Planning Commission Staff Report

Consideration of a Preliminary Plat application for the Pheasant View Plat “D” subdivision consisting of two lots located in the General Commercial (GC-1) zone.

MAPLETON CITY DEVELOPMENT REVIEW COMMITTEE MINUTES

SITE PLAN
PHEASANT VIEW PHASE 2

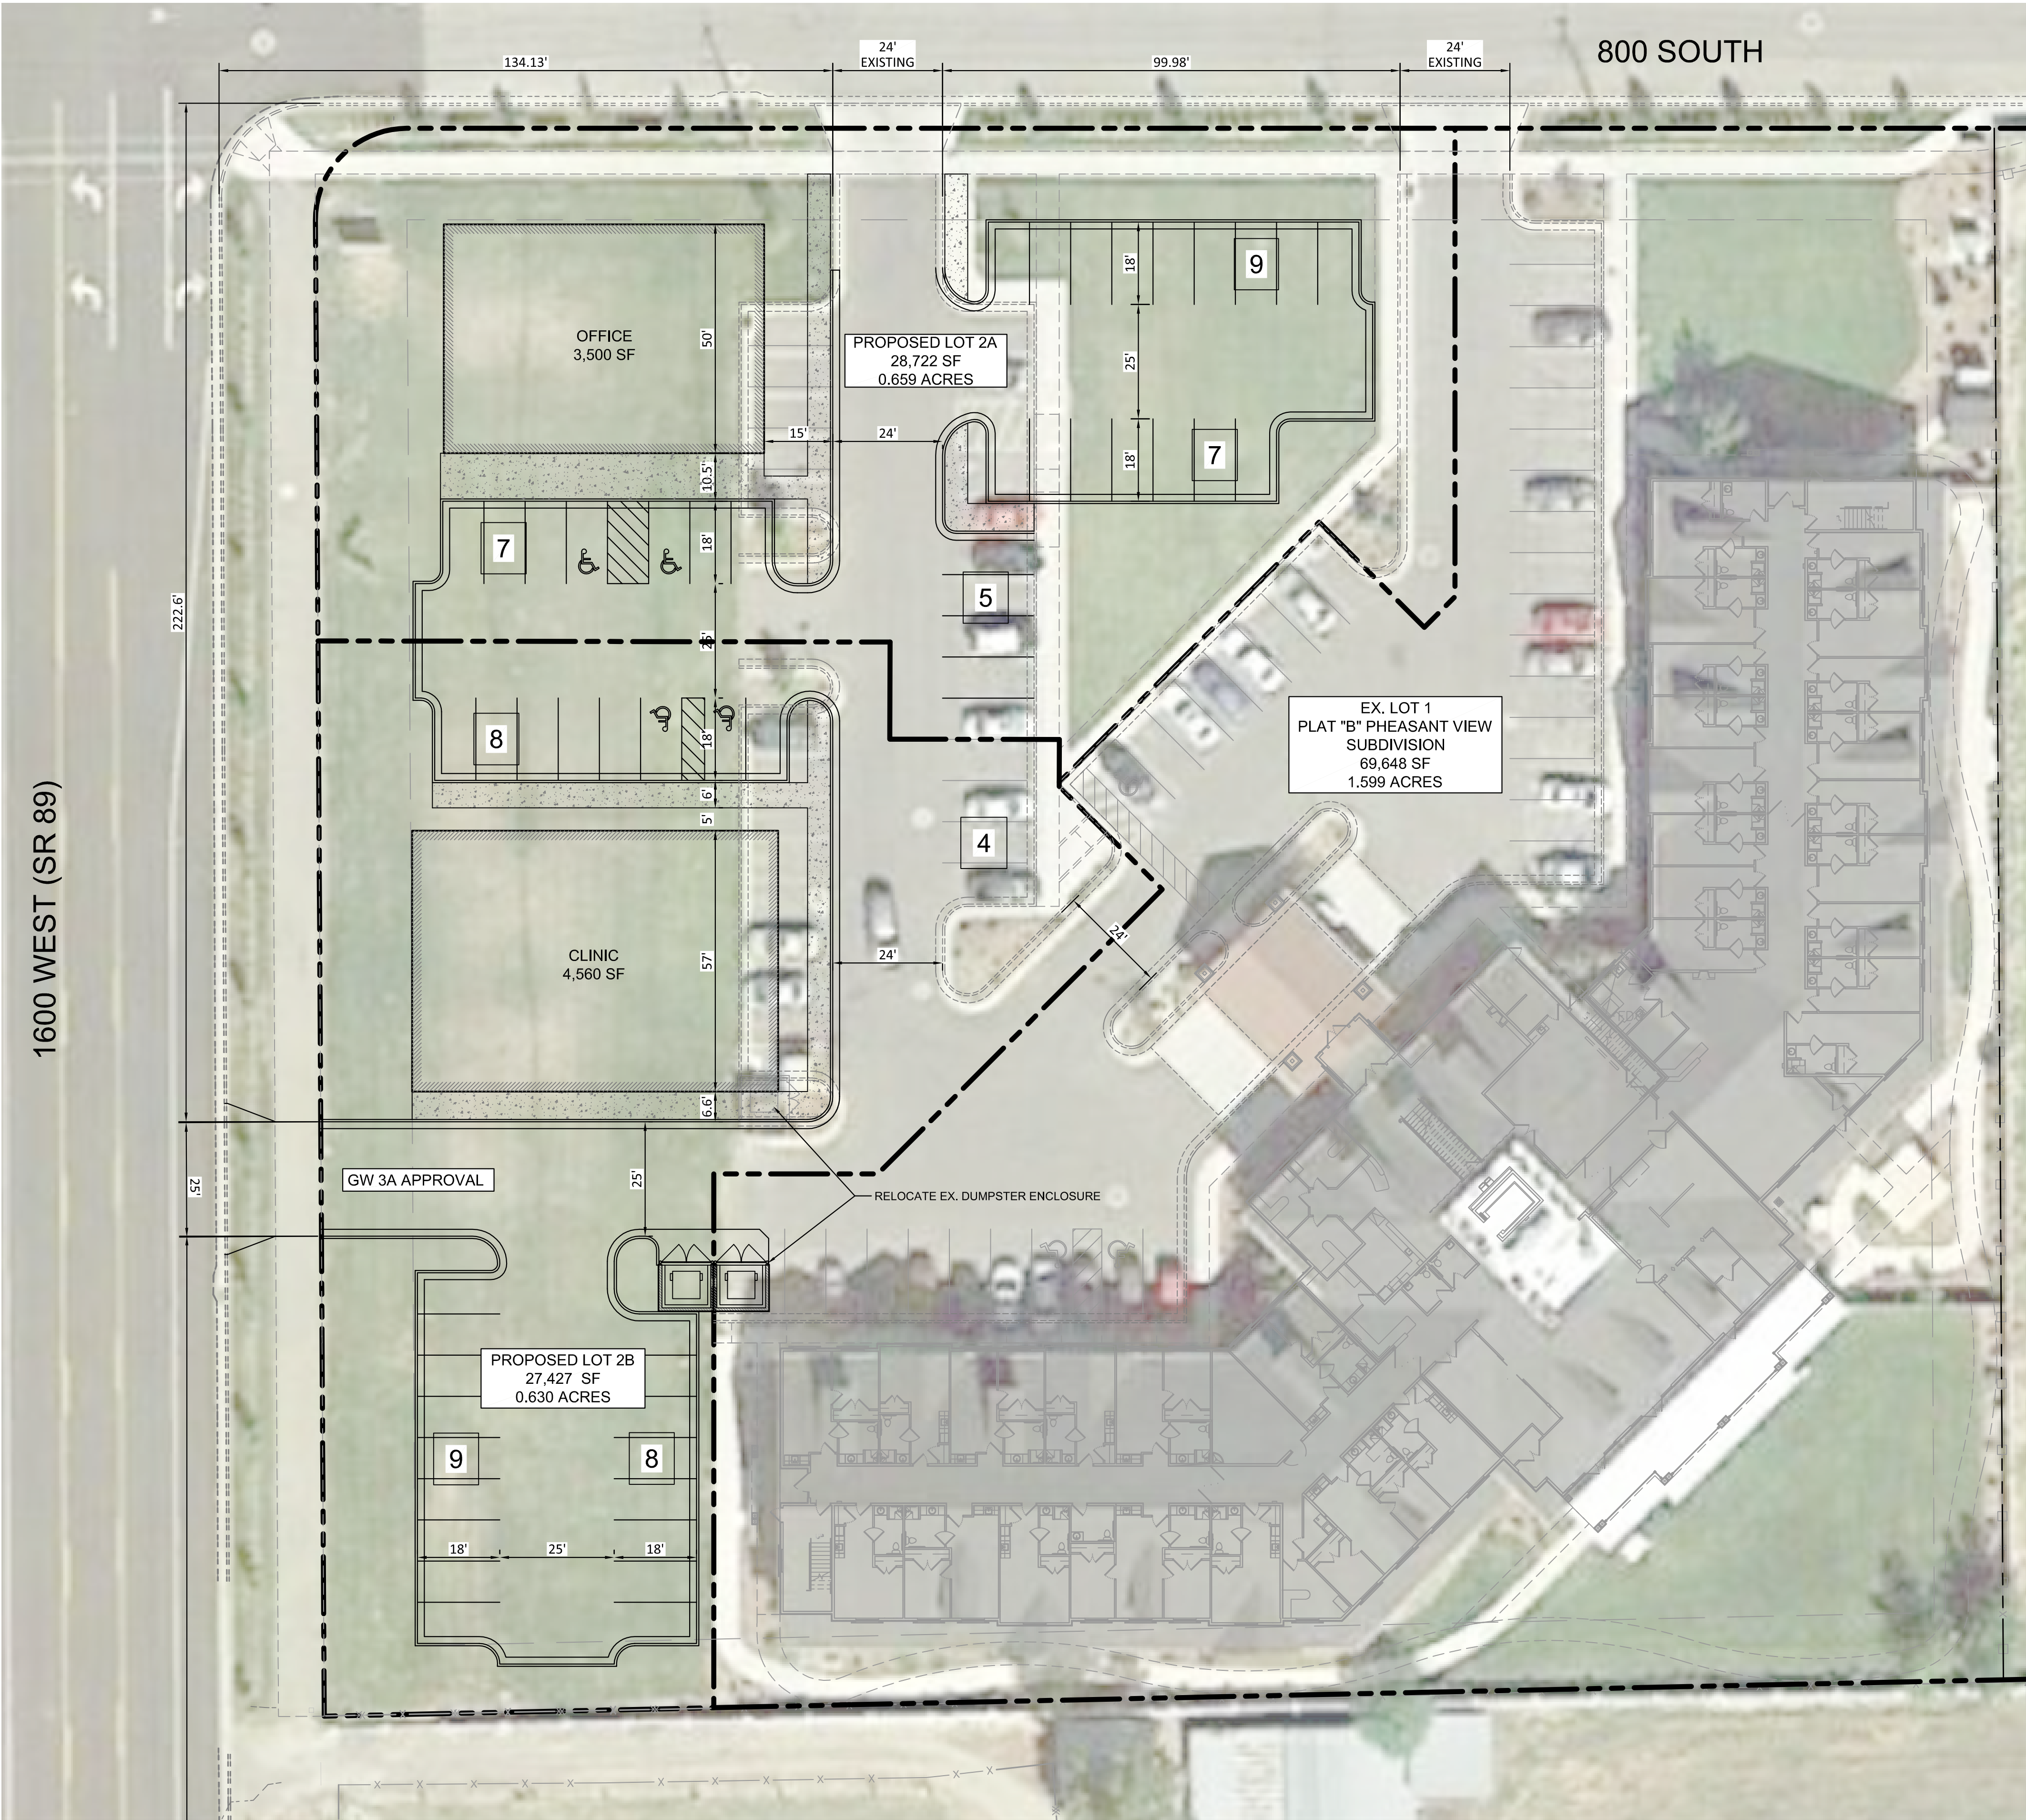
While the site plan is not being reviewed as part of this application, please be aware of the Mapleton City Design Standards for when a formal site plan application is submitted. The standards can be reviewed at:
